Virgil C. Summer Nuclear Station (VCSNS) Units 2 and 3
Combined License Nos. NPF-93 and NPF-94
Docket Nos. 52-027 & 52-028

Subject: LAR 15-09 R1 License Amendment Request: Use of AWS D1.1-2000 Criteria for Structural Welds

**Revised Request for License Amendment Regarding
Use of AWS D1.1-2000 Criteria for Structural Welds
(LAR 15-09 R1)**

Figure 1. Fillet Weld Loading In-Plane of Weld

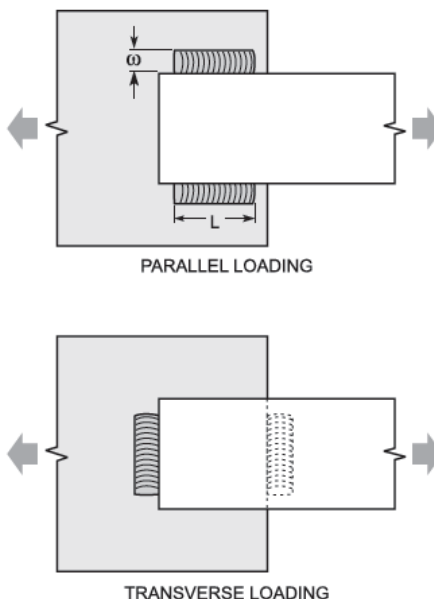
These changes are supported by industry tests that provide the justification for criteria that consider the load directionality. The testing and analysis is reported in an AISC Journal Article, “*Proposed Working Stresses for Fillet Welds in Building Construction*,” by T. R. Higgins and F.R. Preece. The referenced Higgins and Preece paper describes tests on linear fillet welds loaded both parallel to and transverse to the axis of the weld in the plane of the weld, as illustrated in Figure 1. The Higgins and Preece paper provides a factor of safety summary related to a working stress of $0.30F_{EXX}$. The summary of test results demonstrates that the failure of the weld loaded transverse to the axis of the weld is approximately four times $0.30F_{EXX}$.

Figure 1A. Supplemental Provisions for Weld Groups with Longitudinally and Transversely Loaded Elements

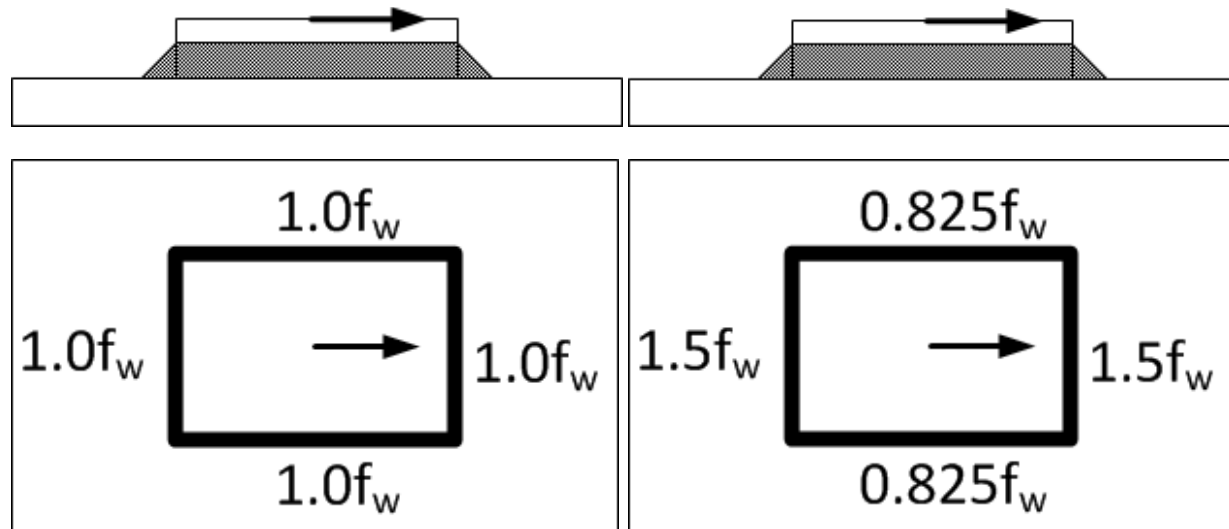
For linear fillet weld groups concentrically loaded in the plane of the weld and consisting of elements oriented both longitudinally and transversely to the direction of applied load, additional provisions are proposed to be included in UFSAR Subsections 3.8.3.2 and 3.8.4.2 to supplement the provisions for directionality included in AWS D1.1-2000. These supplemental provisions address the deformation capability of the elements when combined in a weld group. The strength of the weld group is limited to the larger of (1) the combined strength of the individual weld elements using 1.0 times the strength of the longitudinally oriented element and 1.0 times the strength of the transversely oriented element and (2) the combined strength of the individual weld elements using 0.825 times the strength of the longitudinally oriented element and 1.5 times the strength of the transversely oriented element as illustrated in Figure 1A. These supplemental provisions are more conservative than those in AWS D1.1-2000 and are consistent with provisions in AWS D1.1-2010 Section 2.6.4.4 and Table 2.4 and AISC 360-2010 Section J2.4 (c).

For fillet weld groups concentrically loaded in the plane of axis of the weld and consisting of elements oriented both longitudinally and transversely to the direction of applied load, the deformation capability of the elements shall be considered. As a supplement to the provisions in AWS D1.1-2000, the strength of the weld group is limited to the larger of the two following evaluations:

Figure 3. Circular Fillet Weld Group

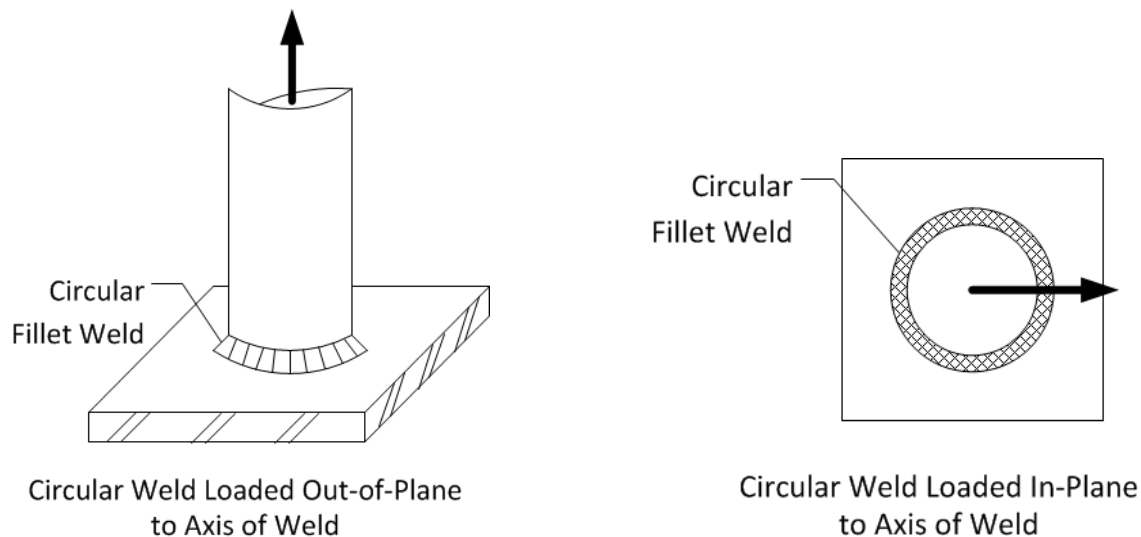
Circular fillet weld groups (e.g., fillet welds to anchor reinforcing bars, fillet welds to round rods, fillet welds to round tubes) are illustrated in Figure 3. A circular-shaped weld group concentrically loaded out-of-plane to the axis of the weld has a loading condition and behavior equivalent to a weld group consisting of straight lines because the shift in the fillet failure angle resulting in the increase in the strength of the weld occurs in the same way whether the axis of the weld is straight or circular. The parameter of interest is the angle that the applied force makes with the axis of the weld.

A finite element analysis (FEA) for out-of-plane loading on the fillet weld was performed to compare the differences between linear welds and concentrically loaded (i.e., loaded through the center of gravity of the weld group) circular weld groups. The loading condition was transverse to and out of the plane of the axis of the weld. Equivalent size and length of weld was used in order to make direct stress comparison. The magnitude and location of the stress path with the largest average equivalent stress was compared in order to confirm that the fillet weld behavior is not influenced significantly by the “shape” of the weld group.

The FEA was then extended to compare the linear out-of-plane behavior to circular weld out-of-plane behavior. The FEA evaluates the circular weld group by creating a solid round bar circumferential-slice-model with a fillet weld circumference equivalent to the length of the fillet weld used in the tests. The circular weld length was based on the centerline projection of the 45 degree effective throat. The model of the welds used equivalent-node attachment of the nominal size of the weld to the base material. No connection was used between welds (i.e., the root notch was maintained in the models). Comparison of the stress results between the linear fillet weld on the cruciform model and the stress results for the circular weld group was performed. The stress comparison confirms that (1) the path of maximum stress through the

weld occurs at approximately 74 degrees to 90 degrees from the horizontal leg for the circular fillet weld; and (2) the average equivalent stresses along the path of maximum stress for the circular fillet weld are approximately equivalent to that for the equivalent-length linear weld.

The use of directionality for circular welds is limited to tension loading concentrically applied out-of-plane to the axis of the weld. For circular welds loaded in-plane to the axis of the weld, the angle of loading measured from the weld longitudinal axis is constantly varying. Due to this complexity, application of AWS D1.1-2000 Section 2.14.4 is excluded for circular welds loaded in-plane to the axis of the weld. The limitation on the use of directionality to out-of-plane load for circular weld groups is included in the licensing basis changes in UFSAR Subsections 3.8.3.2 and 3.8.4.2.

- Where directionality is considered for concentric out-of-plane loading for linear fillet weld groups, including lines and rectangular configurations, the directionality provisions in AWS D1.1-2000 are applied.
- Where directionality is considered for concentric out-of-plane loading for circular-shaped fillet weld configurations, the directionality provisions in AWS D1.1-2000 are applied. The use of directionality provisions in AWS D1.1-2000 for circular-shaped fillet weld configurations is limited to tension loading concentrically applied out-of-plane to the axis of the weld.]*
